Cooper Spur Inn

DAN DILLARD
COOPER SPUR INN
WELL RECONDITIONING PROPOSAL

DES	DATE	SCALE	NAME
DR	12/13/79	DRAWING NO.	1215

STATE WELL NO. 25/DE-6db

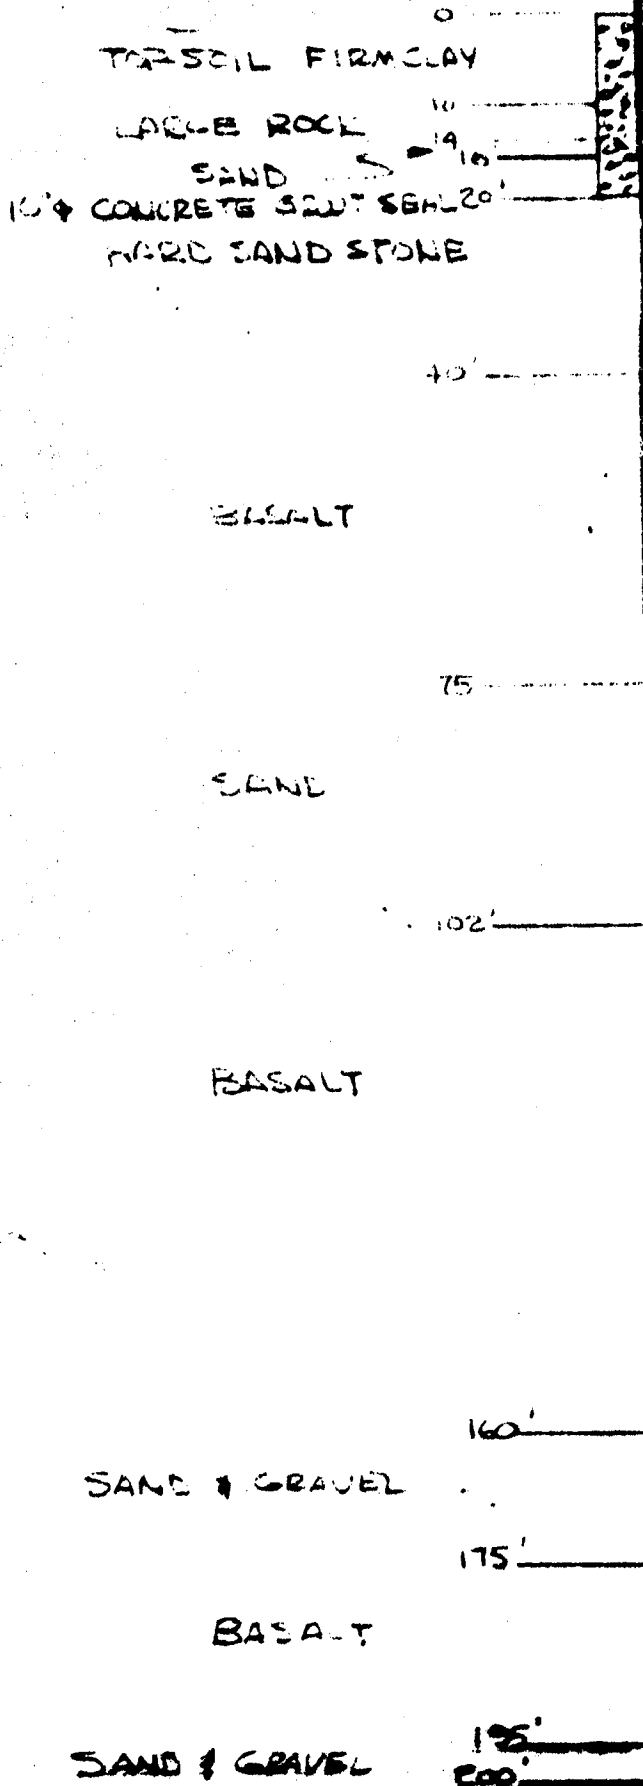
B. CORRECTIONS

10" ϕ BORE HOLE OVER
EXISTING 6" ϕ X .250 WALL
CASING X 40' TO IMPERVIOUS
BASALT LAYER. PRESSURE
GROUT TO GROUND LEVEL
TO SEAL.

4in dia. annular bore drilled over existing 6in.
CASING TO 40'± 5' into hard grey-black basalt
* Gravel backfill in annular bore returned to 40'

It is permitted by the WRD "STANDARDS FOR WATER
WELL CONSTRUCTION" THAT A GRAVEL PACK WELL,
without surface casing, shall have a 4in annular bore
greater than the nominal dia. of the permanent casing.
